MAUELLE SHIREK BUILDING PAINT REMEDIATION & ABATEMENT

ADDENDUM NO. 1
AUGUST 19, 2025

The bid documents for Maudelle Shirek Building Paint Remediation & Abatement Project are amended as follows:

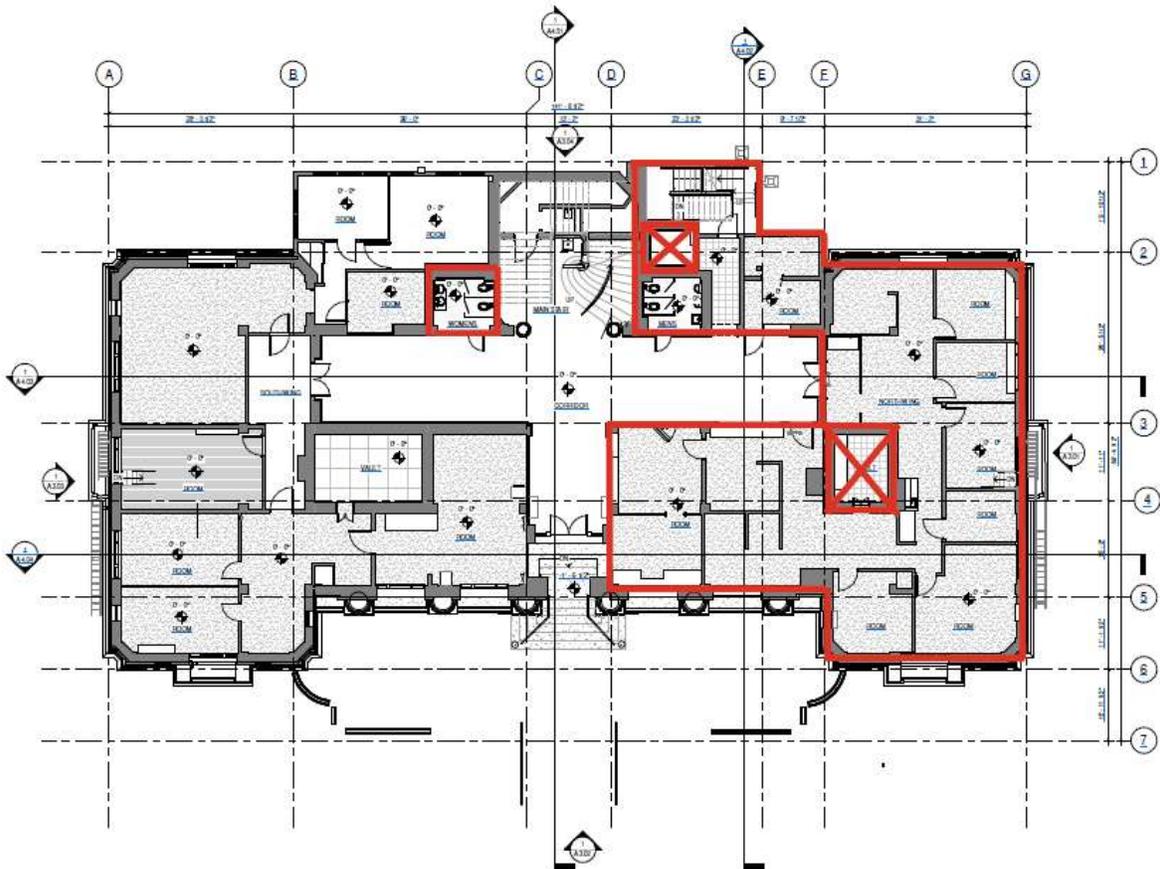
- 2-5. Can you please provide any finish schedule which includes number of rooms & corridors and what need to be painted at each room and corridor - walls, ceilings, doors, door frames, etc.?**
City Response: The scope includes Level 1 areas, with the exception of the stairwell. The stairwell scope covers from the basement level through the second floor, including the area beneath the stairs. See marked up floor plan.
